14 January 2026

Subject: Baldon Wind Farm (SSD-40138508) Response to Request for Amendment Letter

Baldon WIND FARM

Figure 5-1: OSOM/ Heavy Vehicle / Light Vehicle Routes

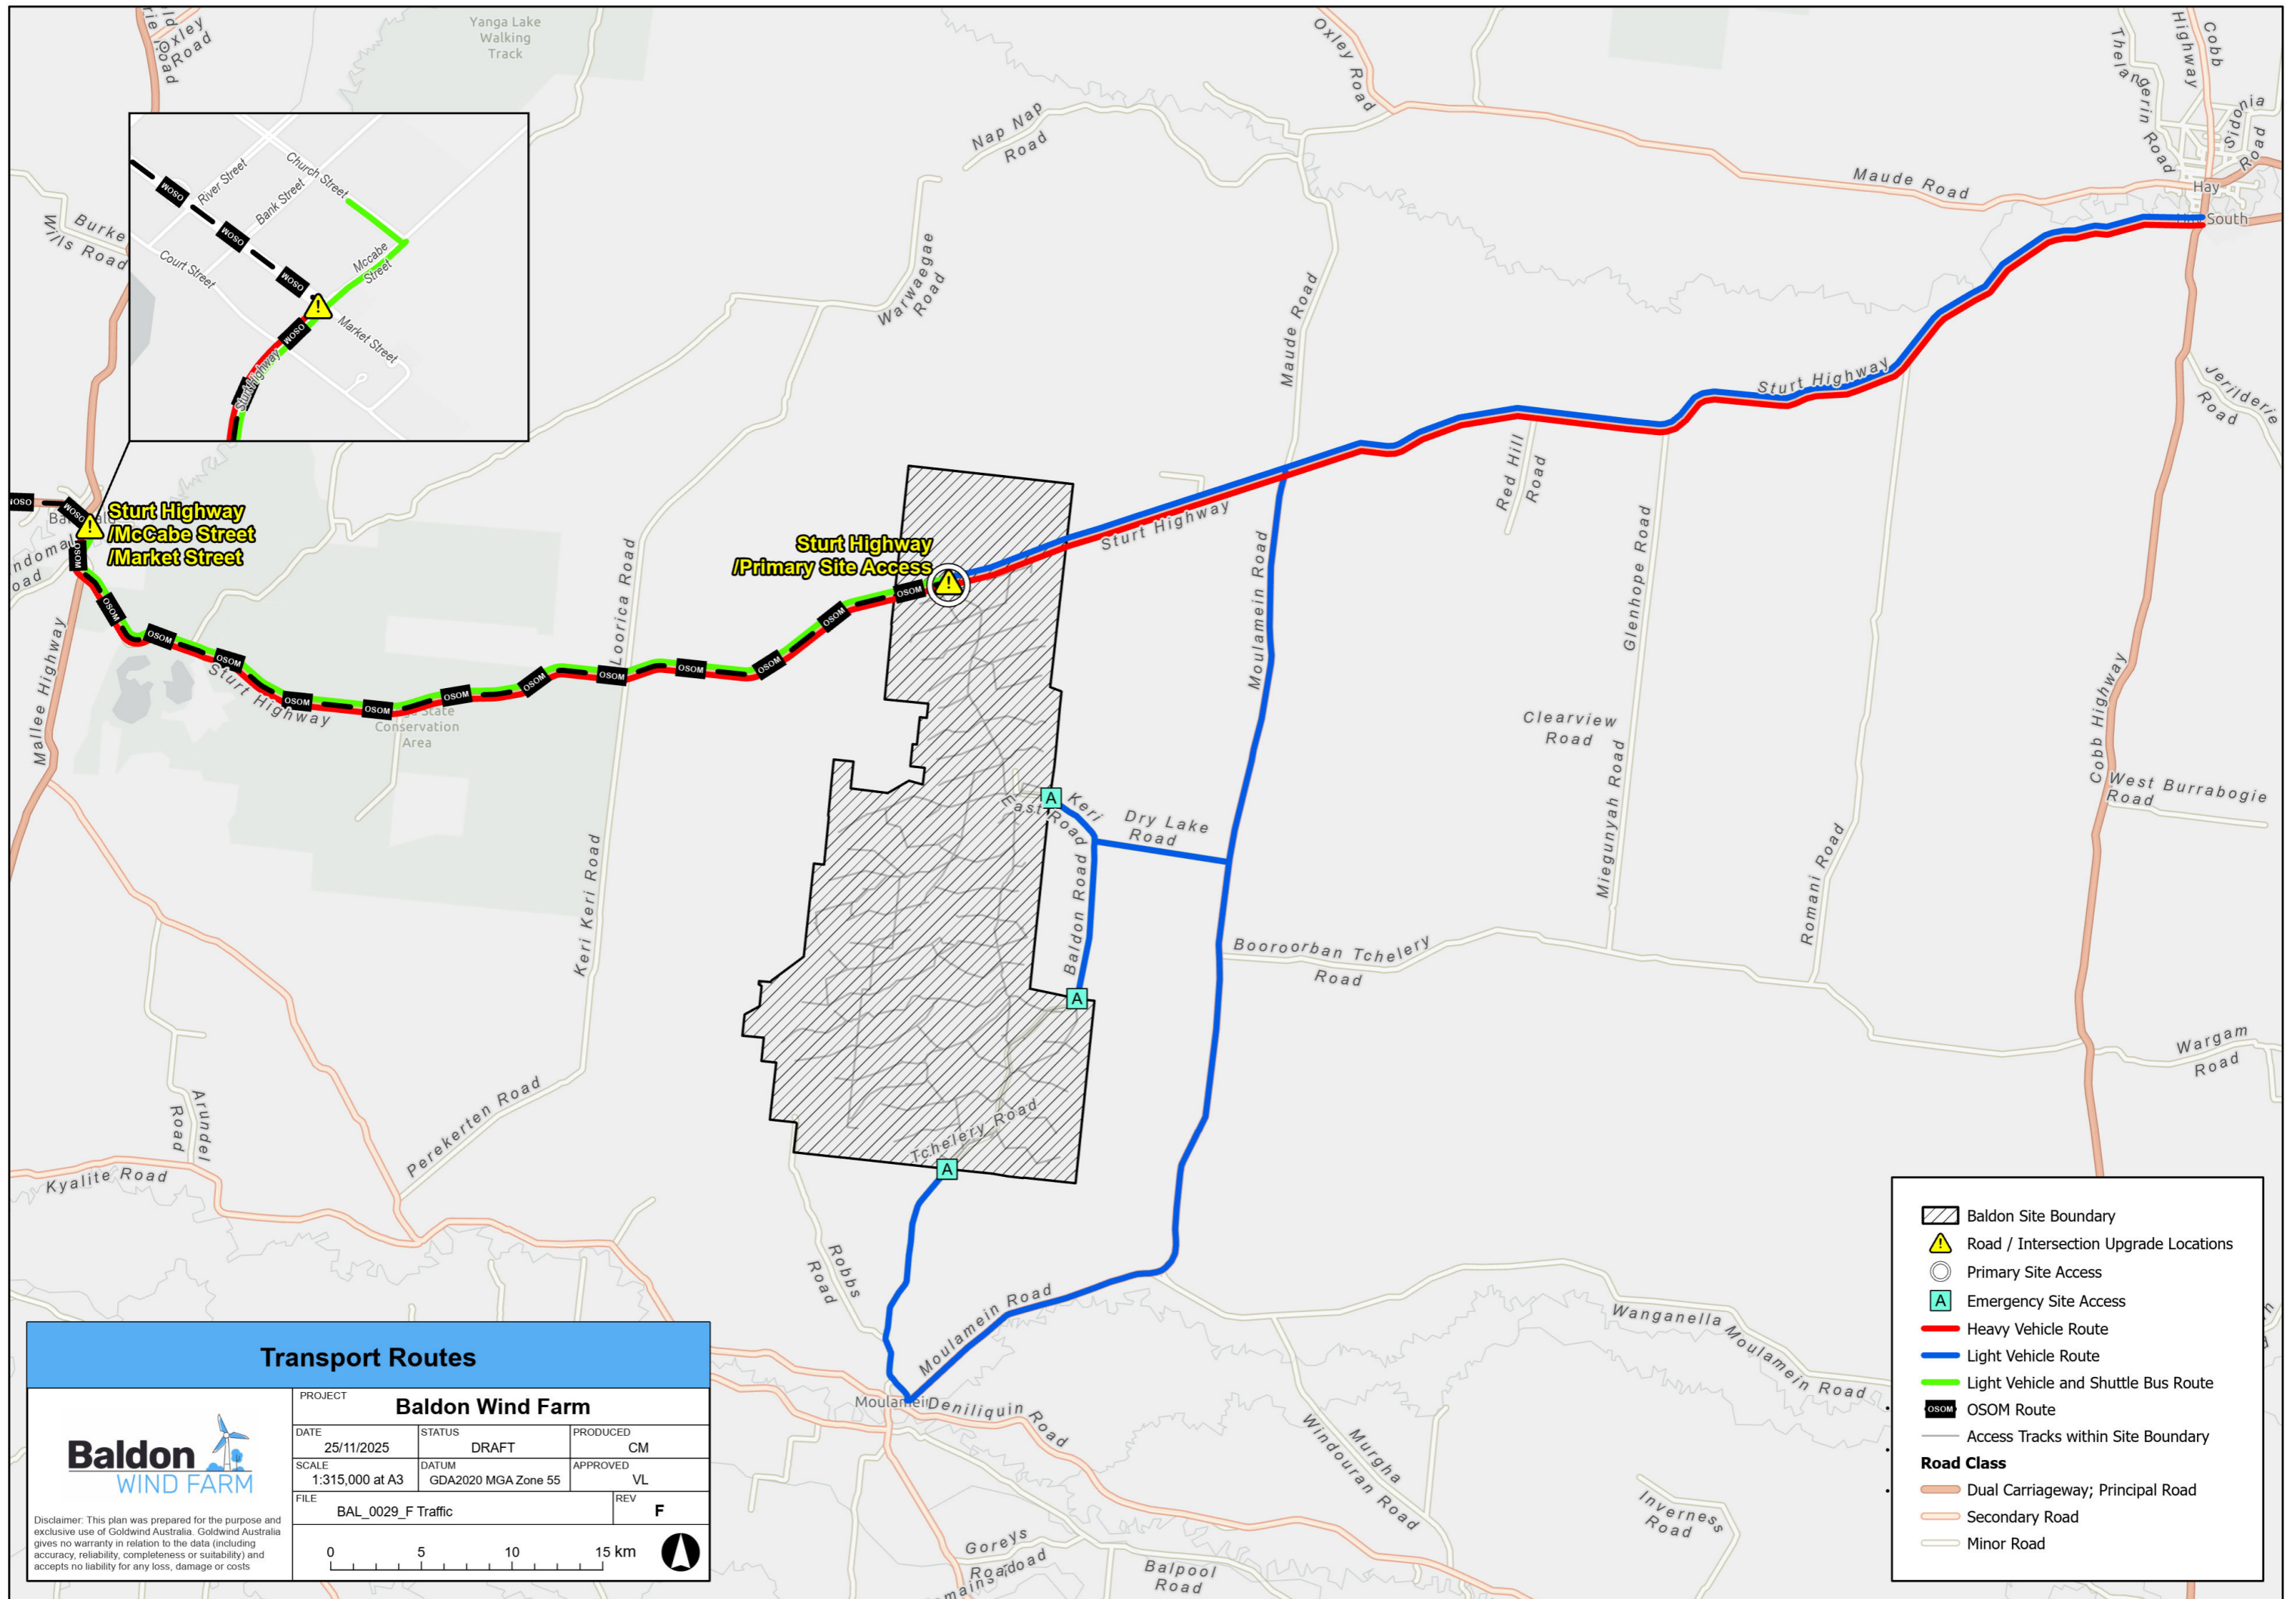
The route study was amended to reflect a single route (except for an alternate route between Port Adelaide and Moorook South for high loads) rather than four which were presented in the EIS. The OSOM route study identified any intersection upgrades or road modifications which may be required to allow for the passage of OSOM. The updated study also provided updated swept path sketches for all road modification as well as loaded dimensions of proposed transport combinations.

The OSOM route, along with the heavy and light vehicle routes which will be utilised to access the Project Area is provided in **Figure 5-1**.
